SUBJECT: FUEL CAP VENTILATION FAILURE

CM-23-045-01-KEEN Date: Dec. 14,2023 Ref.PB No :

MODEL: KX060-5, U56-5, AND U50-5

2. Removing the fuel tank

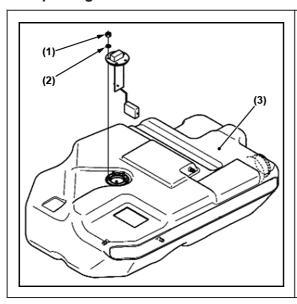
- 1. Remove the fuel tank (1) according to the machine WSM.
- NOTE
- Chapter 5. ENGINE > SERVICING
 4. Repairing > 4.1 Fuel hose and tank
 4.1.1 Removing and installing the fuel tank
- Removing steps 2, 3, 4, 5, 6, 7, 8, 9, 10 can be skipped for KX057-5.
- Removing steps 2, 3, 4, 5, 6 can be skipped for U55-5 and U48-5.
- (1) Fuel tank
